# MICROCHIP PIC18F6310/6410/8310/8410

## PIC18F6310/6410/8310/8410 Rev. B3 Silicon Errata

The PIC18F6310/6410/8310/8410 Rev. B3 parts you have received conform functionally to the Device Data Sheet (DS39635B), except for the anomalies described below. Any Data Sheet Clarification issues related to the PIC18F6310/6410/8310/8410 will be reported in a separate Data Sheet errata. Please check the Microchip web site for any existing issues.

**FIGURE 1: SCK PULSE VARIATION USING TIMER2/2**

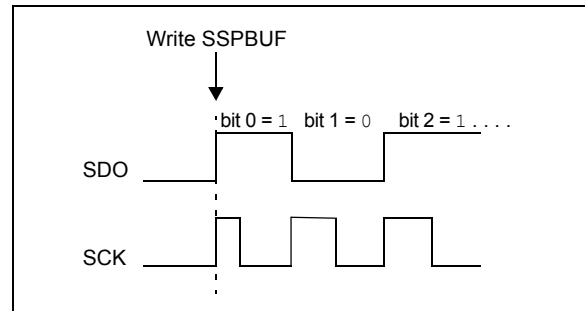
When the SPI is using Timer2/2 as the clock source, a shorter than expected SCK pulse may occur on the first bit of the transmitted/received data (Figure 1).

To avoid producing the short pulse, turn off Timer2 and clear the TMR2 register, load the SSPBUF with the data to transmit and then turn Timer2 back on. Refer to Example 4 for sample code.
